PCN #: 2403

PCN Title: Qualification of Additional Wafer Solderable Front Metal Plating, Back Grinding and Back Metal Process Source, Additional Wafer Source, or Additional Assembly and Test site for Select Products

PRODUCT CHANGE NOTICE

PCN-2403 REV 1

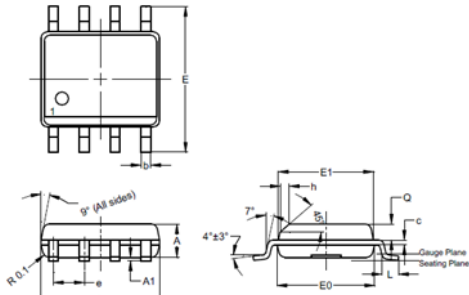
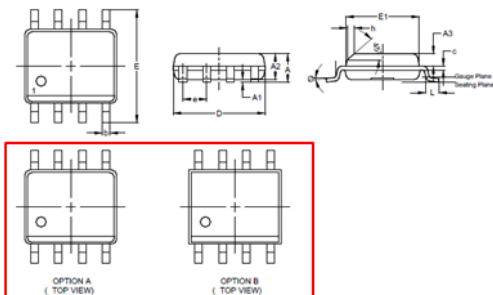
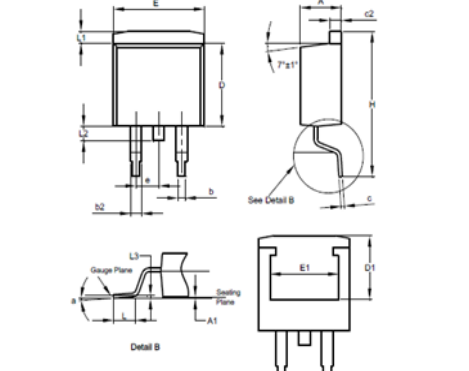
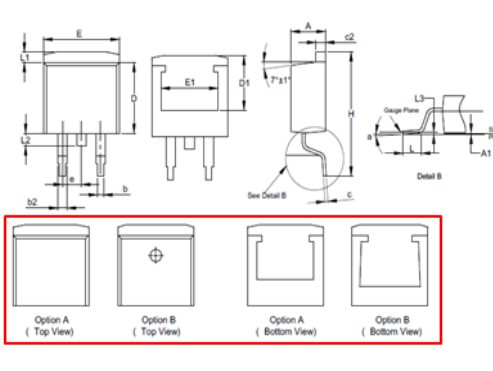
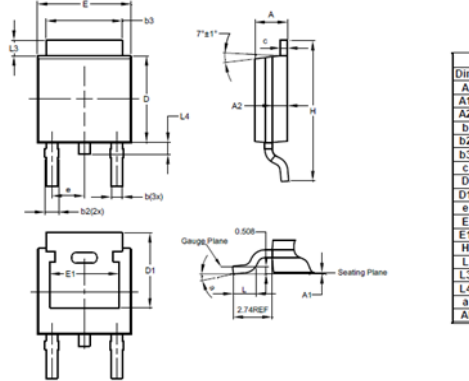
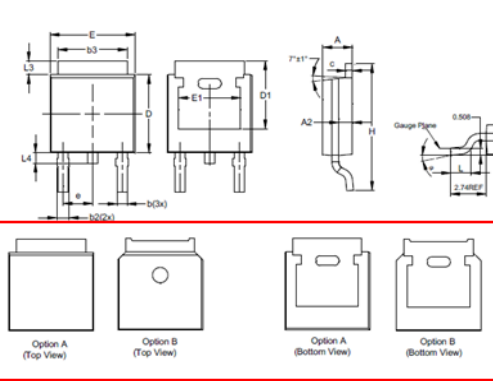
<p>From : Current POD listed in the device datasheet</p> <p>Baseline POD (Diodes internal Shanghai and Chengdu Assembly & Test Site (SAT/CAT)</p> <p>Baseline SO-8</p>	<p>Change To : Combined POD will be listed in the device datasheet</p> <p>Combined POD (SAT/CAT + TSHT) covers baseline's POD.</p> <p>Combined SO-8: Option A (SAT/CAT-Baseline) + Option B (TSHT)</p>																																																																																																																																																
<p>SO-8</p>  <table><tr><th>Dim</th><th>Min</th><th>Max</th><th>Typ</th></tr><tr><td>A</td><td>1.40</td><td>1.50</td><td>1.45</td></tr><tr><td>A1</td><td>0.10</td><td>0.20</td><td>0.15</td></tr><tr><td>b</td><td>0.30</td><td>0.50</td><td>0.40</td></tr><tr><td>c</td><td>0.15</td><td>0.25</td><td>0.20</td></tr><tr><td>D</td><td>4.85</td><td>4.95</td><td>4.90</td></tr><tr><td>E</td><td>5.90</td><td>6.10</td><td>6.00</td></tr><tr><td>E1</td><td>3.80</td><td>3.90</td><td>3.85</td></tr><tr><td>E0</td><td>3.85</td><td>3.95</td><td>3.90</td></tr><tr><td>e</td><td>—</td><td>—</td><td>1.27</td></tr><tr><td>h</td><td>—</td><td>—</td><td>0.35</td></tr><tr><td>L</td><td>0.62</td><td>0.82</td><td>0.72</td></tr><tr><td>Q</td><td>0.60</td><td>0.70</td><td>0.65</td></tr></table> <p>All Dimensions in mm</p>	Dim	Min	Max	Typ	A	1.40	1.50	1.45	A1	0.10	0.20	0.15	b	0.30	0.50	0.40	c	0.15	0.25	0.20	D	4.85	4.95	4.90	E	5.90	6.10	6.00	E1	3.80	3.90	3.85	E0	3.85	3.95	3.90	e	—	—	1.27	h	—	—	0.35	L	0.62	0.82	0.72	Q	0.60	0.70	0.65	<p>SO-8 (Standard)</p>  <table><tr><th>Dim</th><th>Min</th><th>Max</th><th>Typ</th></tr><tr><td>A</td><td>0.10</td><td>0.25</td><td>—</td></tr><tr><td>A1</td><td>1.25</td><td>1.65</td><td>—</td></tr><tr><td>A2</td><td>0.50</td><td>0.70</td><td>—</td></tr><tr><td>b</td><td>0.30</td><td>0.51</td><td>—</td></tr><tr><td>c</td><td>0.15</td><td>0.25</td><td>—</td></tr><tr><td>D</td><td>4.80</td><td>5.00</td><td>—</td></tr><tr><td>E</td><td>5.80</td><td>6.20</td><td>6.00</td></tr><tr><td>E1</td><td>3.80</td><td>4.00</td><td>—</td></tr><tr><td>e</td><td>—</td><td>—</td><td>1.27</td></tr><tr><td>h</td><td>0.25</td><td>0.50</td><td>—</td></tr><tr><td>L</td><td>0.45</td><td>0.82</td><td>—</td></tr><tr><td>Q</td><td>0.60</td><td>0.70</td><td>—</td></tr></table> <p>All Dimensions in mm</p>	Dim	Min	Max	Typ	A	0.10	0.25	—	A1	1.25	1.65	—	A2	0.50	0.70	—	b	0.30	0.51	—	c	0.15	0.25	—	D	4.80	5.00	—	E	5.80	6.20	6.00	E1	3.80	4.00	—	e	—	—	1.27	h	0.25	0.50	—	L	0.45	0.82	—	Q	0.60	0.70	—

Dim	Min	Max	Typ																																																																																																																																														
A	1.40	1.50	1.45																																																																																																																																														
A1	0.10	0.20	0.15																																																																																																																																														
b	0.30	0.50	0.40																																																																																																																																														
c	0.15	0.25	0.20																																																																																																																																														
D	4.85	4.95	4.90

E	5.90	6.10	6.00																																																																																																																																														
E1	3.80	3.90	3.85																																																																																																																																														
E0	3.85	3.95	3.90																																																																																																																																														
e	—	—	1.27																																																																																																																																														
h	—	—	0.35																																																																																																																																														
L	0.62	0.82	0.72

Q	0.60	0.70	0.65																																																																																																																																														
Dim	Min	Max	Typ																																																																																																																																														
A	0.10	0.25	—																																																																																																																																														
A1	1.25	1.65	—																																																																																																																																														
A2	0.50	0.70	—																																																																																																																																														
b	0.30	0.51	—

c	0.15	0.25	—																																																																																																																																														
D	4.80	5.00	—																																																																																																																																														
E	5.80	6.20	6.00																																																																																																																																														
E1	3.80	4.00	—																																																																																																																																														
e	—	—	1.27																																																																																																																																														
h	0.25	0.50	—
